**SB-GA8-2014-116**

## Service Bulletin

Installation of a Secondary Starter Solenoid

All GA8 & GA8-TC 320 aircraft

**Figure 2: View Looking Aft on Firewall**

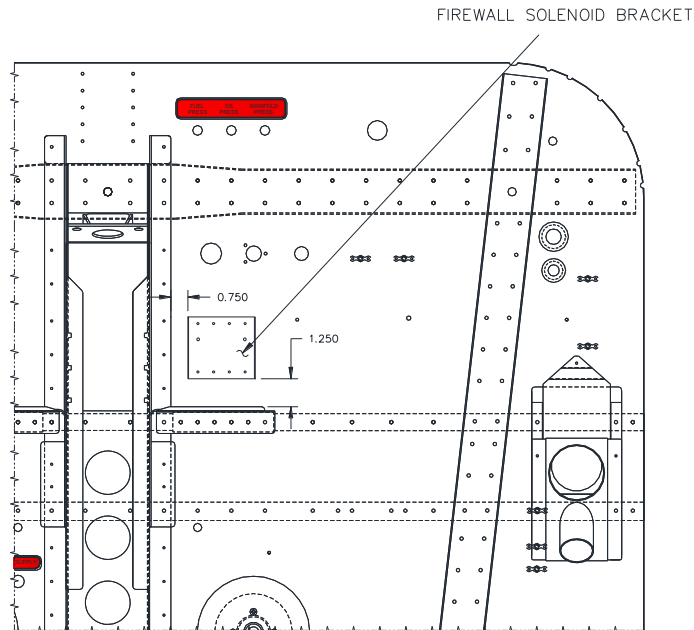
- 1.3. Locate and undo the Insulation Firewall Centre LH (GA8-258012-025) to provide access to aft face of the firewall in the area of the solenoid mounting. Retain the fastening hardware.
- 1.4. Place the Firewall Solenoid Bracket (GA8-714025-021) in position as per Figure 2 and back drill the 8 x  $\varnothing 0.098$ " bracket mounting holes through the firewall. Open holes up to  $\varnothing 0.128$ " and clip in location.

- 1.5. Back drill 2 x  $\varnothing 0.128$ " solenoid mounting holes through the firewall. Open holes up to  $\varnothing 0.191$ ".
- 1.6. Disassemble and deburr all drilled components and restore any primer removed.

**Figure 4: Cable Routing, View Looking Inboard/Aft On Firewall LHS**

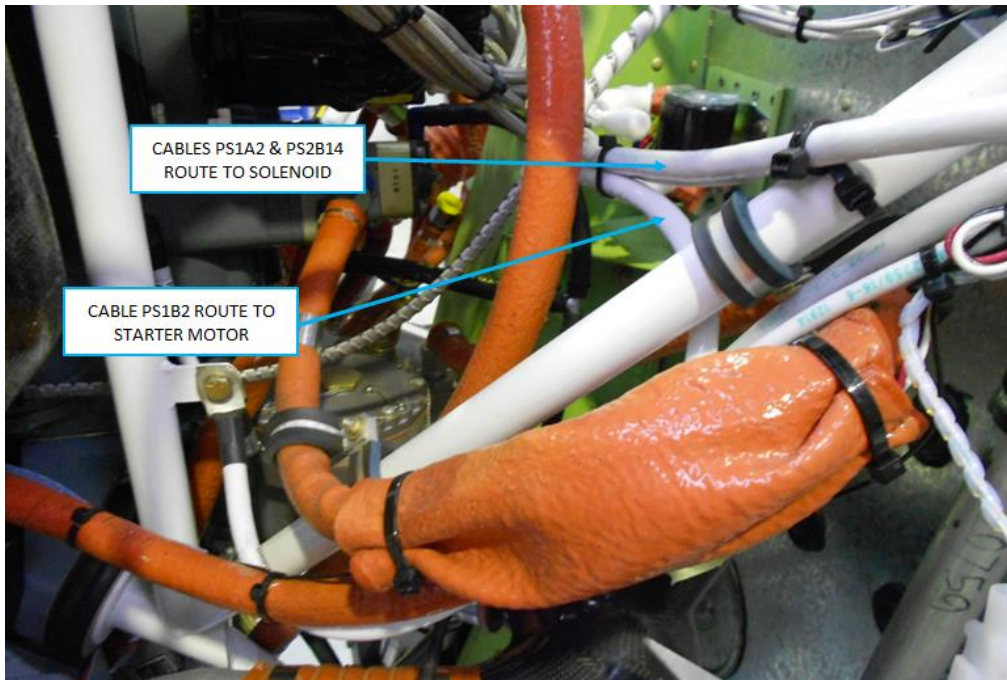
- 2.6. The cable assembled in step 2.4 is to be inserted through the supplied Terminal nipple (MS25171-1S) and attached to the respective terminal of the solenoid with the hardware supplied. Slide the Terminal nipple into position. See Figure 4 for the cable routing for PS1A2 & PS2B14 from firewall to Solenoid.

**Figure 5: Cable Routing, View Looking Inboard on LHS**

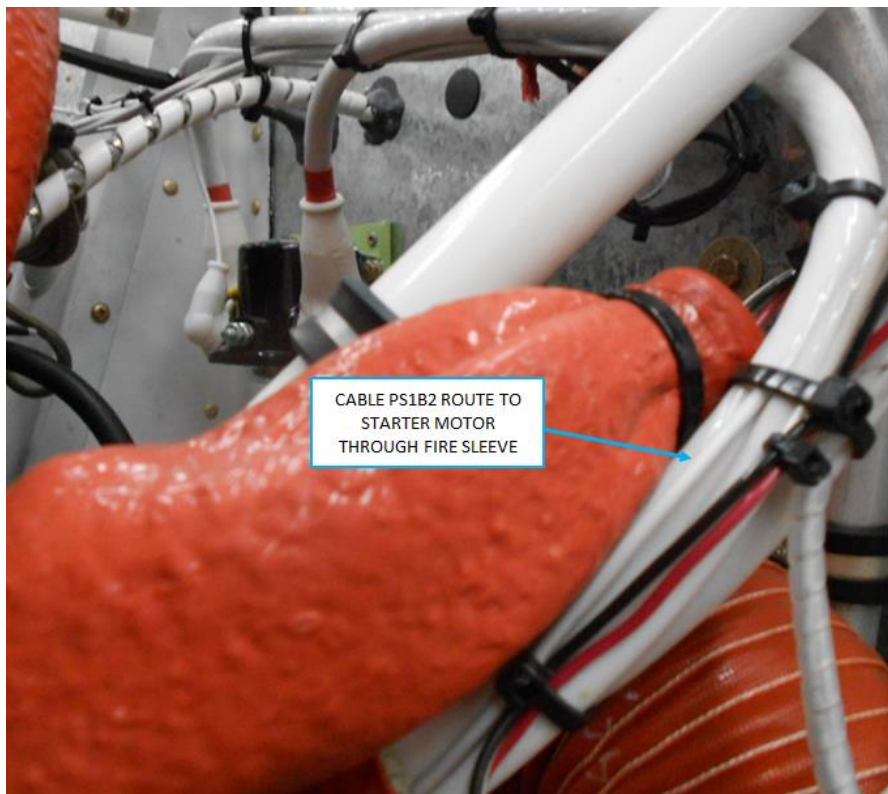
- 2.7. Using the supplied 55" length of Wire AWG White ETFE (MS22759/16-2-9), crimp the terminal ring red (324112-0) and heat shrink the sleeve to both ends. Identify the cable PS1B2.
- 2.8. Slide the cable PS1B2 assembled in step 2.7 through the fire sleeve forward to the engine starter motor and attach with the hardware retained in step 2.2. Pass the other end through the supplied terminal nipple (MS25171-3S) and attach to the outboard terminal of the solenoid with the hardware supplied. Slide the terminal nipple into position. For routing details see Figure 4 & Figure 5.
- 2.9. If installing a new starter at this time, verify freedom from rubbing or chafing of looms with adjacent equipment or structure. In particular, verify that that wiring connected to the starter motor is not chafing against the second alternator if installed.

2.10. When cables pick up on existing looms, remove existing cable ties and attach new ties to the looms. Where there are no existing looms, the new cables are to be tied together. For both cases an approved aerospace cable tie is to be used at standard spacing.

**Figure 7: Modified Configuration**

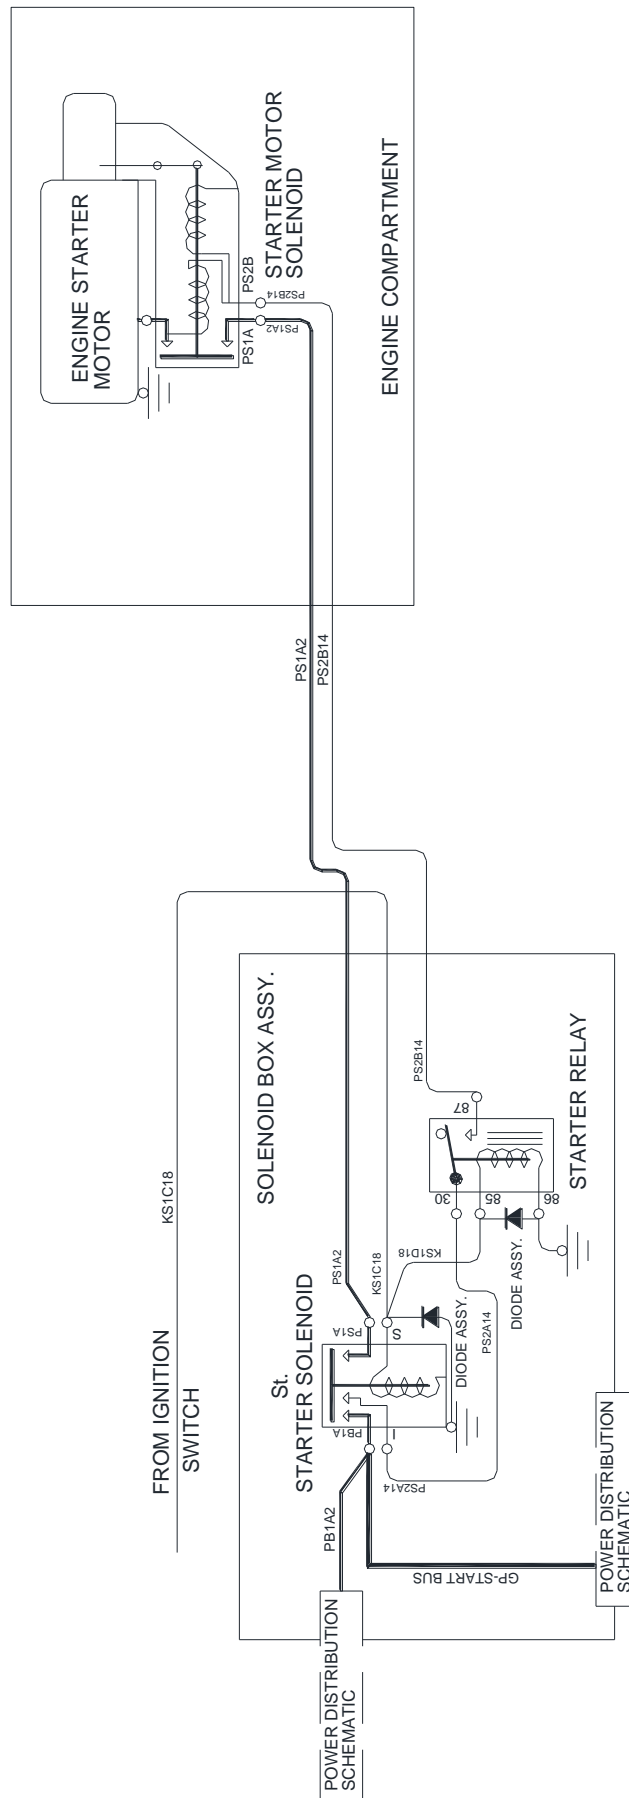
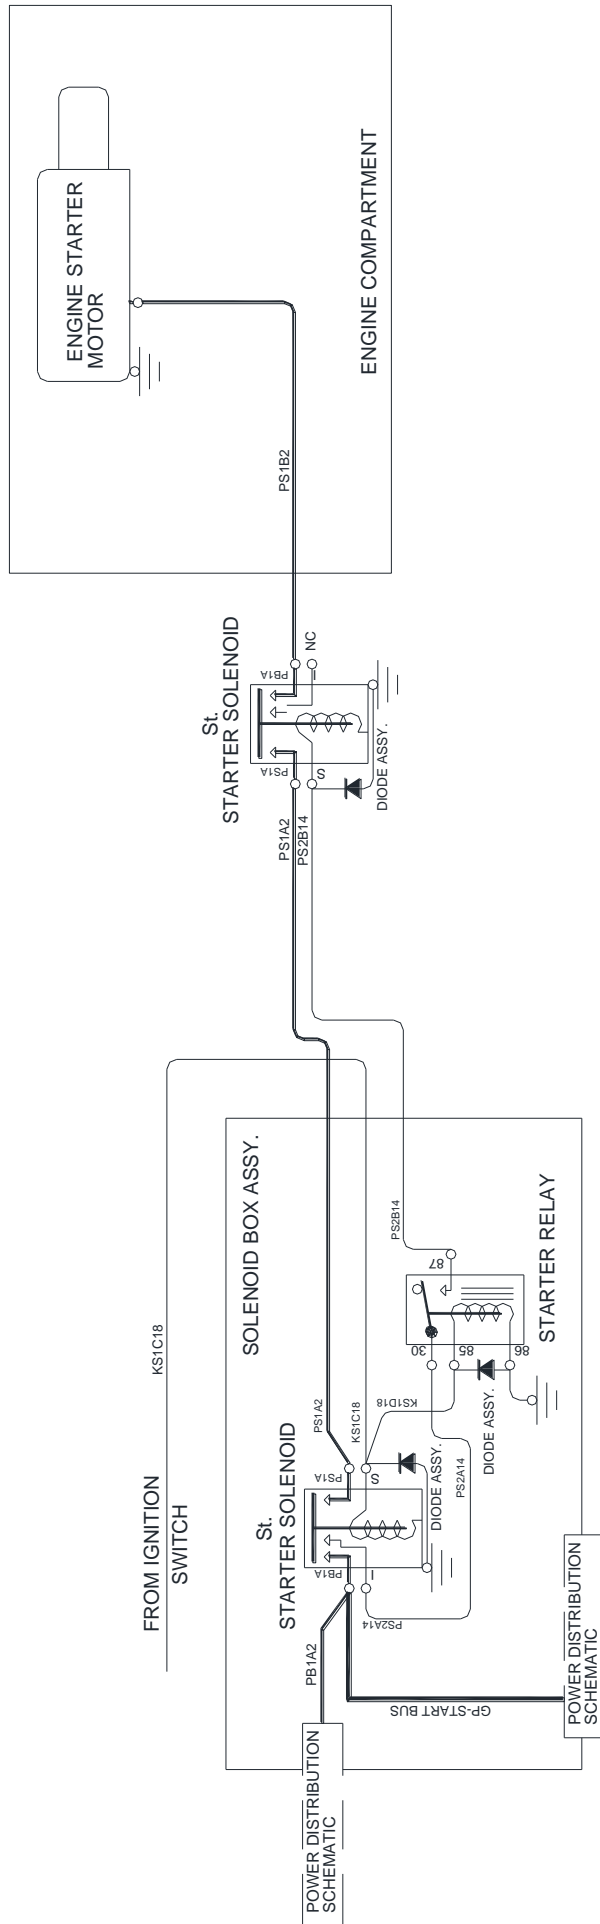
- 2.1. An overview of the original and modified wiring diagrams is shown in Figure 6 and Figure 7.
- 2.2. Refer to Figure 6, on the engine starter motor (mounted below the engine) locate the terminals PS1A & PS2B. Undo the cables attached to the terminals identified as PS1A2 & PS2B14. Retain hardware for reinstallation. Remove both cables through the existing fire sleeve back to the firewall.

- 2.3. Crimp the terminal ring red (324112-0) to the PS1A2 cable and heat shrink the sleeve.
- 2.4. Crimp the terminal ring blue (4357-6868) to the PS2B14 cable and heat shrink the sleeve.

- 2.5. Pass the cable assembled in step 2.3 through the supplied Terminal nipple (MS25171-3S) and attached to the respective terminal of the Solenoid with the hardware supplied.

**Figure 8: Arrows indicate where a check for continuity is to be made.**

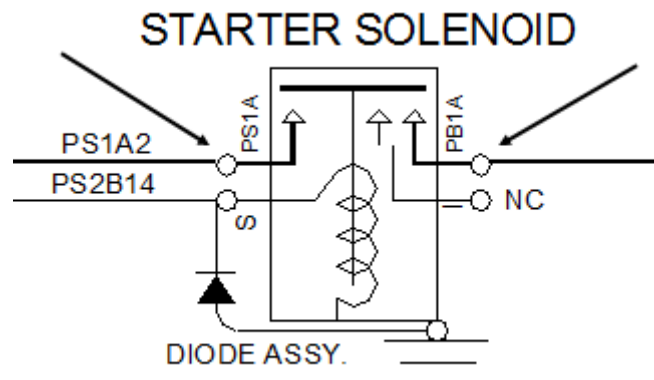
Confirm that the installed solenoid contactor terminals are open circuit in the absence of power to the field of the externally mounted starter solenoid. Refer to Figure 8. Replace the solenoid if an electrical path exists between the terminals.

A latent defect check for “welded contacts” of each individual solenoid is to be carried out every 100 hours in accordance with instructions specified in the applicable aircraft Service Manual.
